Communication from Public

Re: LA River Bikepath Phase IV, Draft MND on Council File 23-0722

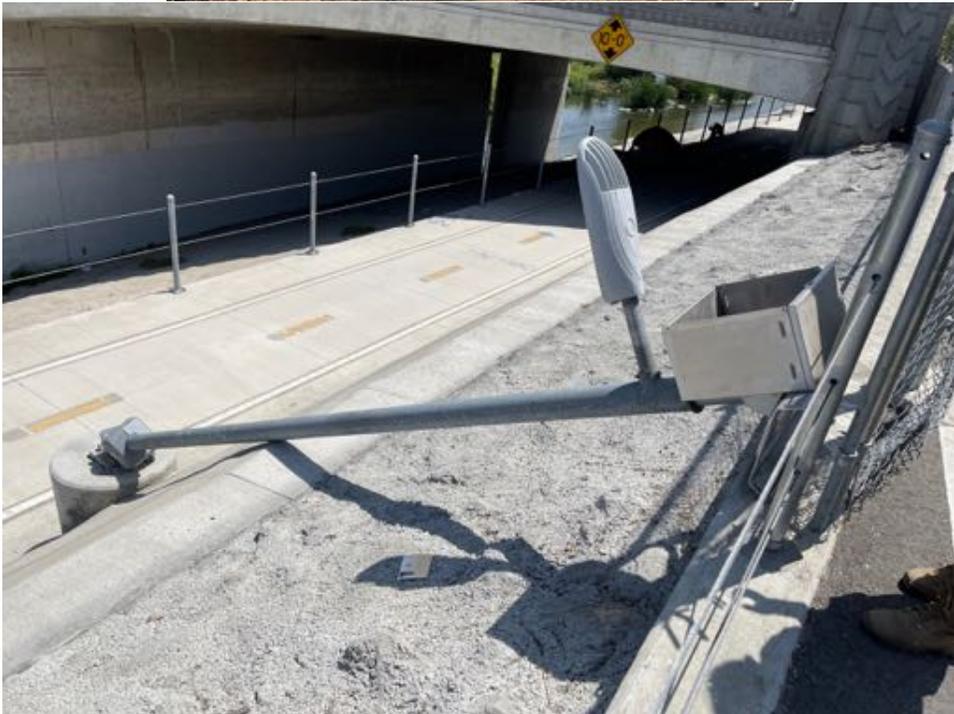
For years the east end of the current bikepath has had wide open gaps from cuts in the CalTrans chain link fencing. The secure metal DOT gates and wings at the east end offer little restriction because they do not extend far enough. They function as an island and people simply go around them. As was conveyed to DOT at previous meetings, metal security fencing needs to extend from the current east end to the bridle path at Tunnel #6 to prevent cyclists from bypassing the current gated-off location at the current terminus of the existing bikepath. (see photos)

Moreover, 'no bike' signs are painted out, graffiti'd or removed altogether. Even cyclists who wish to follow protocol do not have legible signage to inform them. This is a lack of maintenance that leads to a risk to the public.

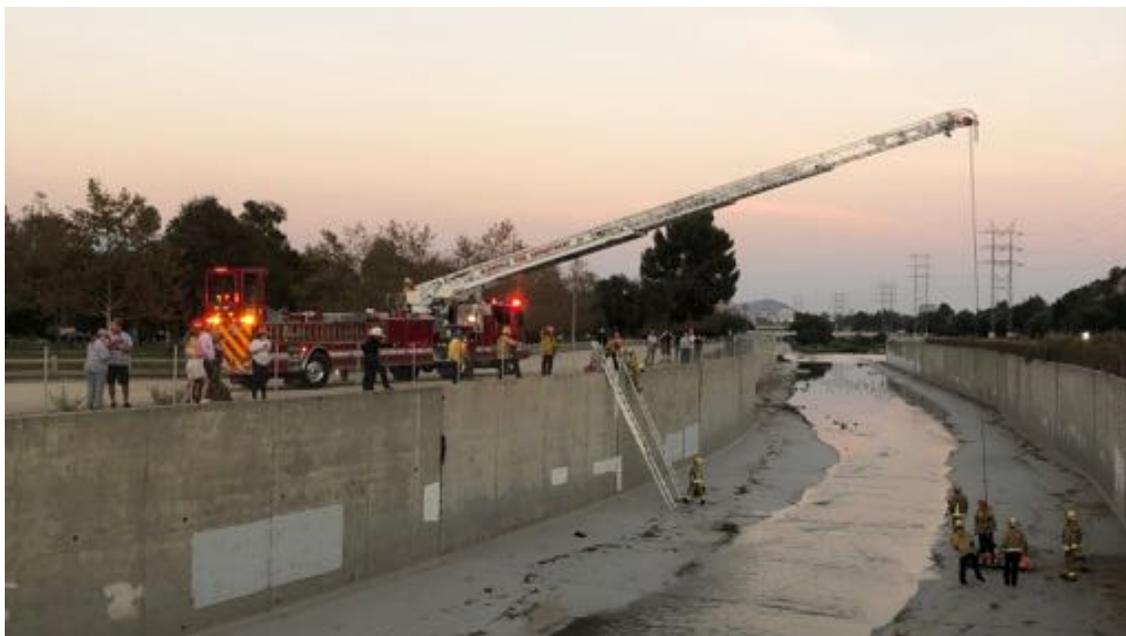
How will LA/DOT ensure electronic GPS's (such as Google Maps) mark this as a DEAD END with NO outlet, so cyclists with a destination will transfer onto Zoo Drive as originally intended? As currently proposed, this has been characterized by cyclists as 'a Bike Path To Nowhere'. Until Caltrans reviews, designs, funds and builds a bridge at the Forest Lawn 134 entrance/exit, I'm told this has limited attraction to cyclists.

How will LA/DOT design the path to be striped to avoid the same misconception as currently exists at Riverside Bridge? The current striping leads cyclists onto the horse trail incorrectly believing this is in fact currently a bicycle path, and leads to hostile interactions which could end in a rider falling from their horse over the very low chainlink fence. A photo is attached of a rider being rescued, thankfully alive, from a fall face-first into the concrete-lined river as a result of a horse being startled. A cyclist could be also injured in an altercation, not realizing a horse's concern.
